# EASTERN CORRIDOR SEGMENTS II AND III (PID 86462) SR 125/SR 32 FOCUS AREA ADVISORY COMMITTEE MEETING NOTES

EASTERN CORRIDOR SEGMENTS II AND III (PID 86462)  
**SR 125/SR 32 FOCUS AREA**  
**ADVISORY COMMITTEE MEETING #1**  
ANDERSON CENTER • FEB. 9, 2018  
9:30 a.m. – 11:30 a.m.

**Figure X-1G and 125-4**  
MODIFY RAMP CONNECTION FROM S.R. 32 TO S.R. 125  
TO ROUNDABOUT

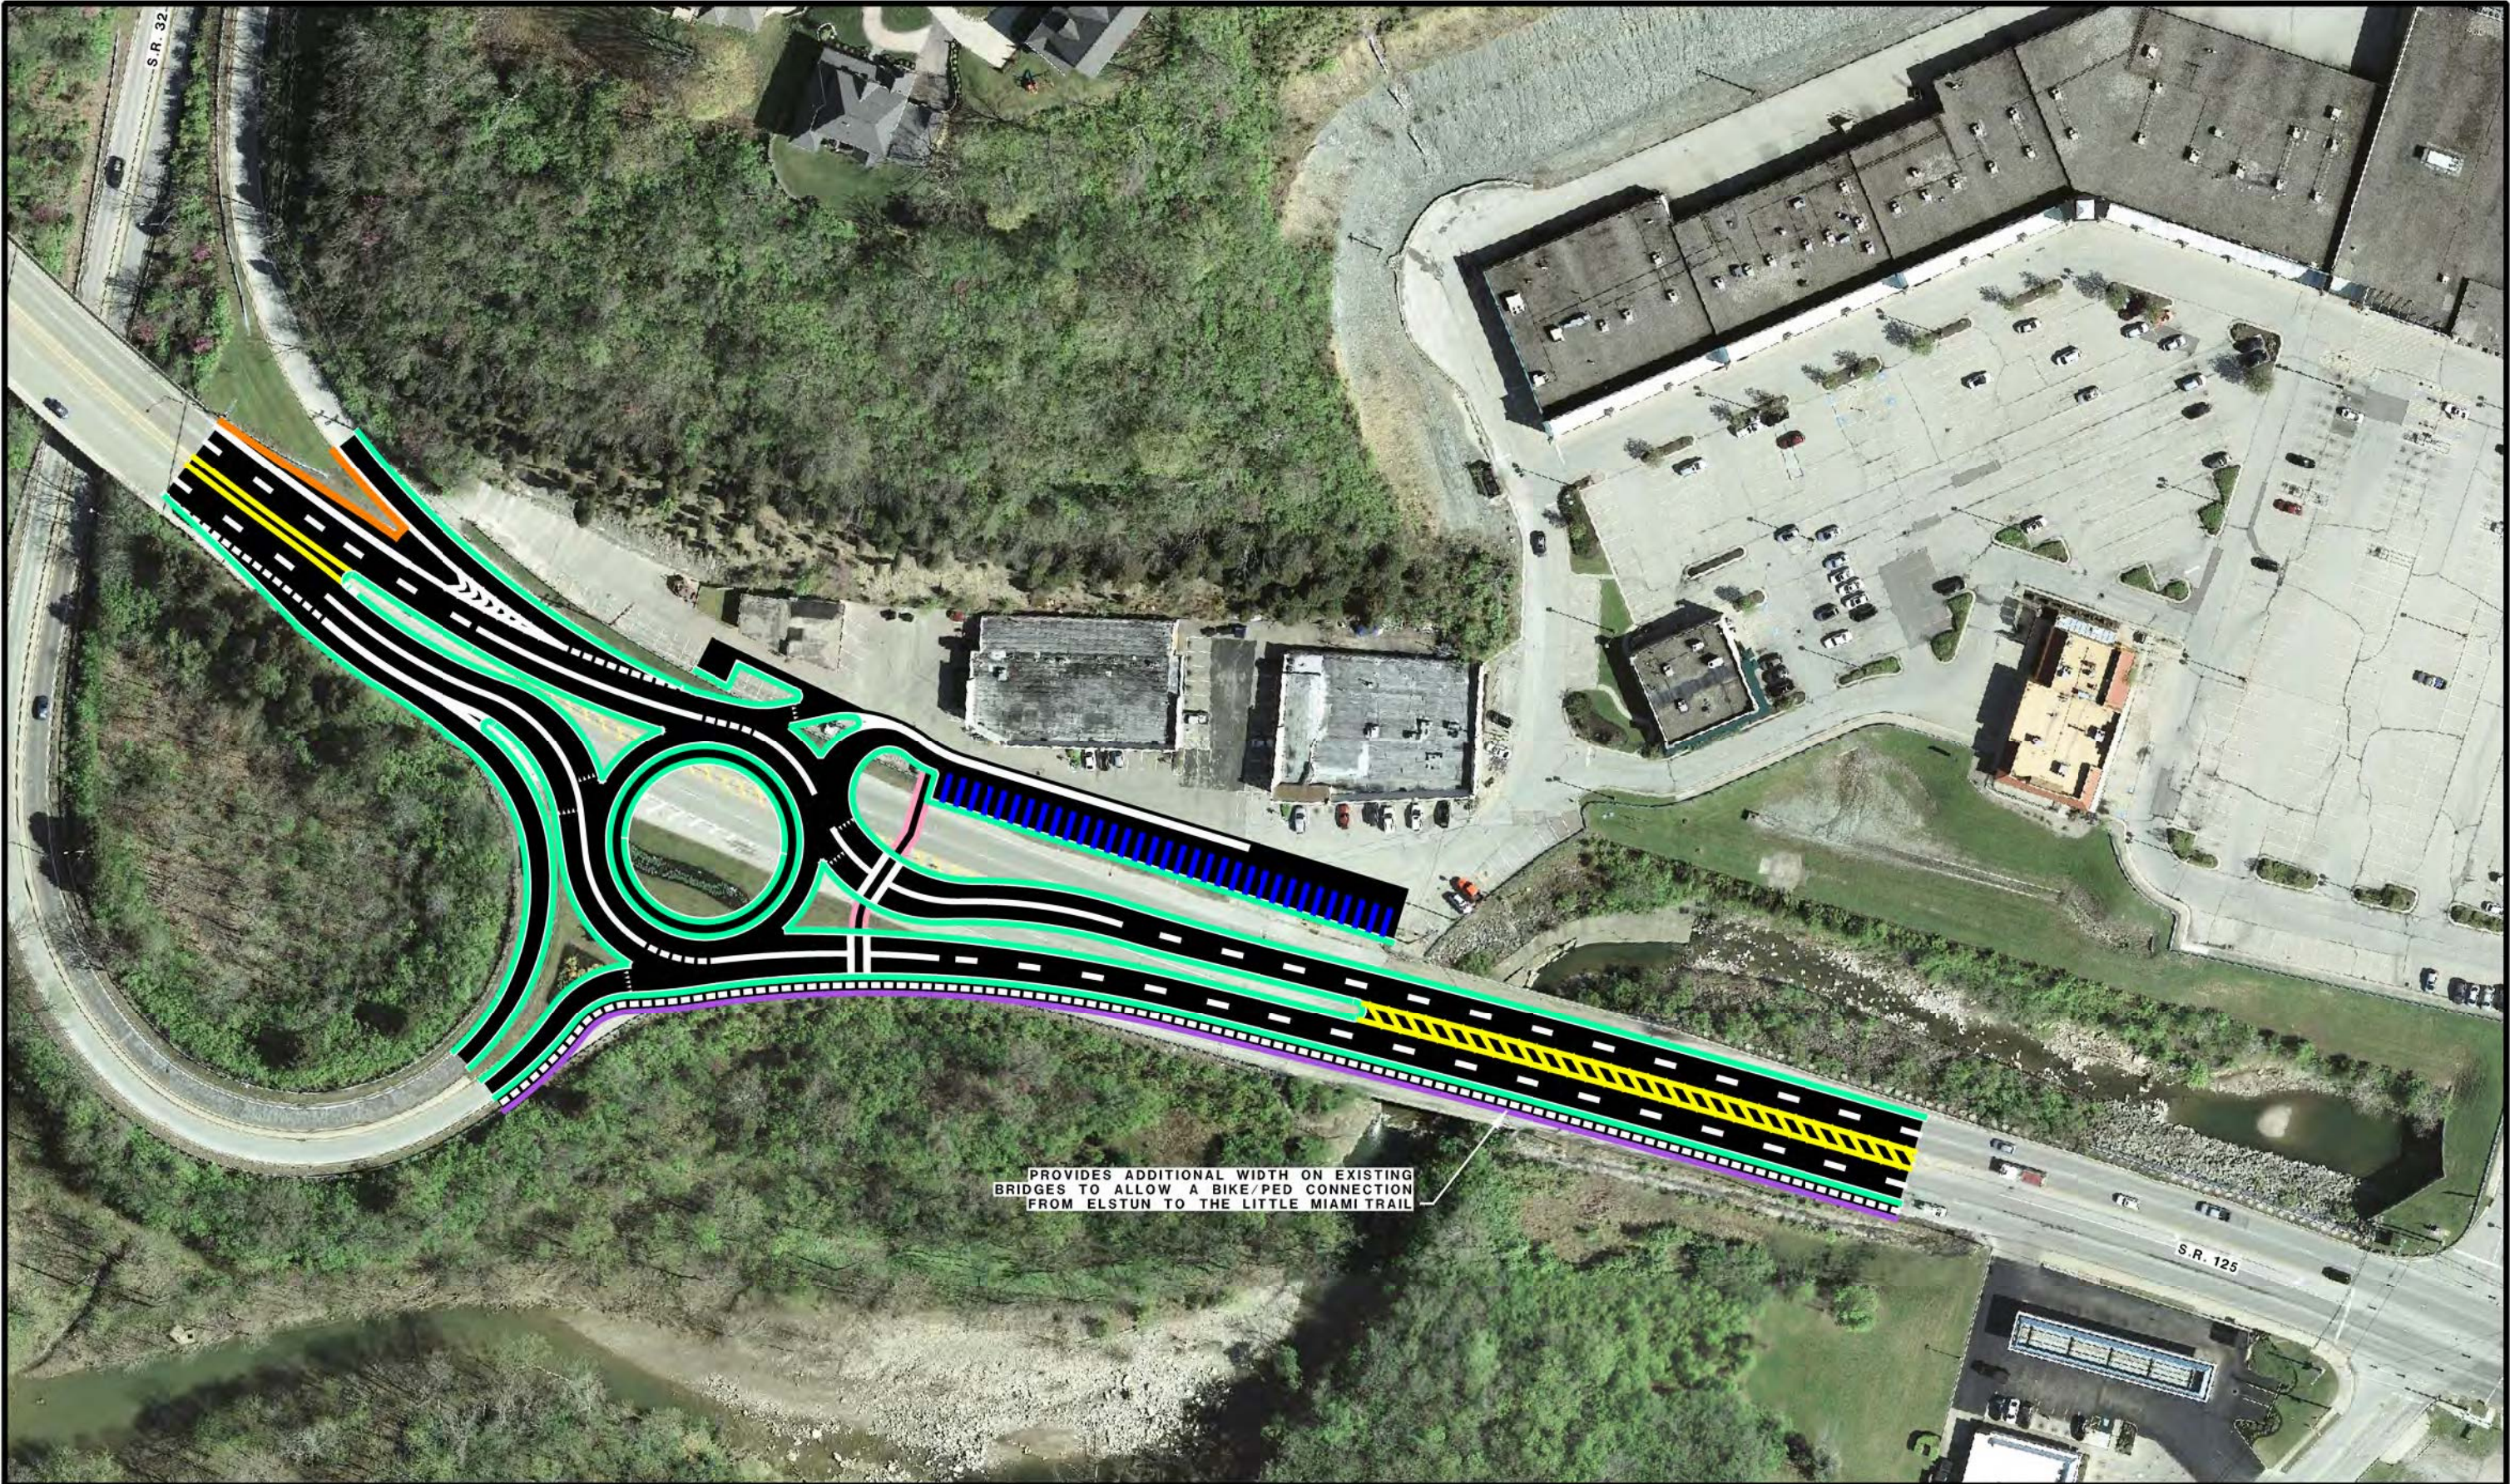
- Advisory Committee reviewed a simulation of how traffic would flow as part of this concept.
- The simulation showed a significant delay on SR 32; it would be difficult for traffic using the SR 32 ramp to access SR 125 with the amount of vehicles traveling east/west traffic on SR 125 (approximately 1,900 eastbound vehicles per hour).
- This concept would provide an alternative route for getting to SR 32 if the ramp under SR 125 floods.
- No additional comments were received following the 8/20 meeting.

- No further study. Traffic simulation showed excessive delay for SR 32 ramp.

**Figure 32-1A**  
**CROSSING FROM TURPIN LAKE PLACE  
AND ROPES DRIVE TO THE LITTLE MIAMI TRAIL**

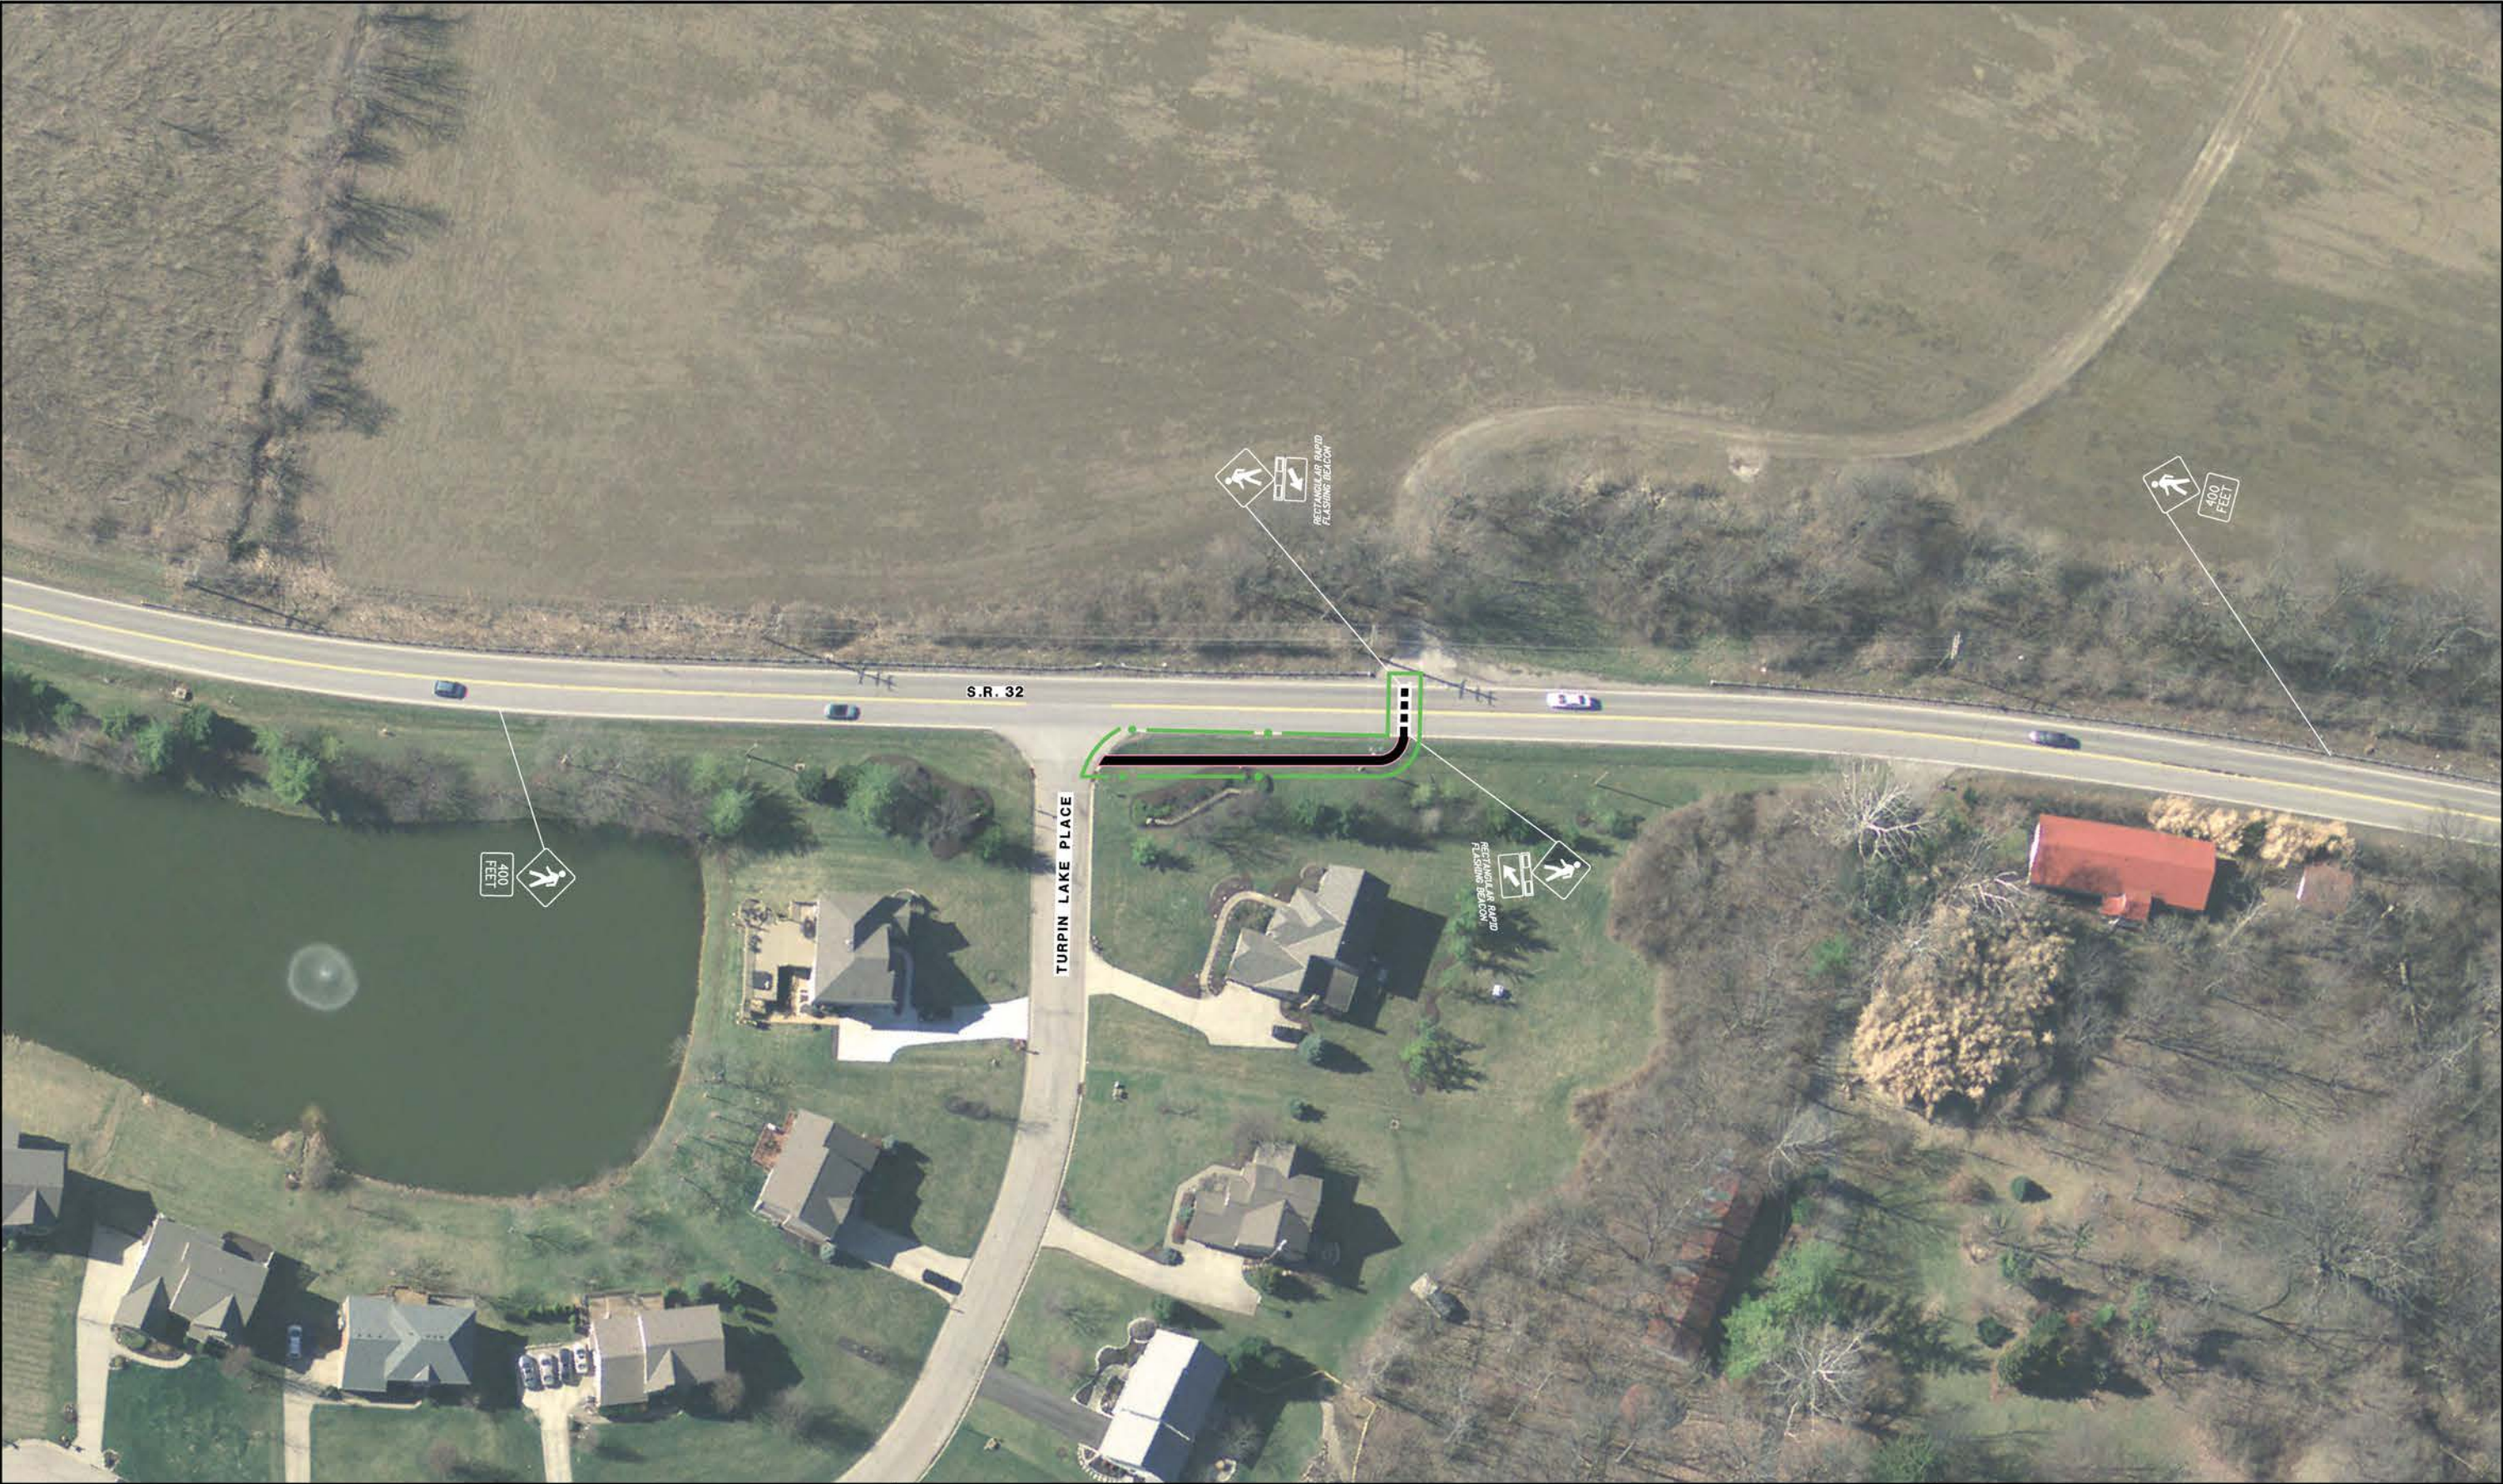
- This concept was presented as A7 at the October Open House meetings.*
- Public feedback tended toward neutral to supportive for this concept (38% Neutral, 25% Like, 24% Strongly Support). See Public Feedback Ratings Summary, next page.
  - A comment received from the public questioned how many people this project would serve. ODOT noted that this project would most likely be constructed in conjunction with other shared-use projects [such as 32-2a (A9)]. Therefore, its benefits extend beyond the homes located on Turpin Lake Place.
  - The Advisory Committee agreed that this concept is not a stand-alone project and they are interested in it only if implemented with other projects such as, 32-2a (A9).
  - The committee discussed designating this concept as a medium priority, coupling it with 32-2a (A9) and completing a speed study to

- Include in the Implementation Plan as a medium priority.
- Link project with 32-2a (A9).
- Investigate crosswalk location at intersection of SR 32 and Turpin Lake Place.
- Perform speed study on SR 32.
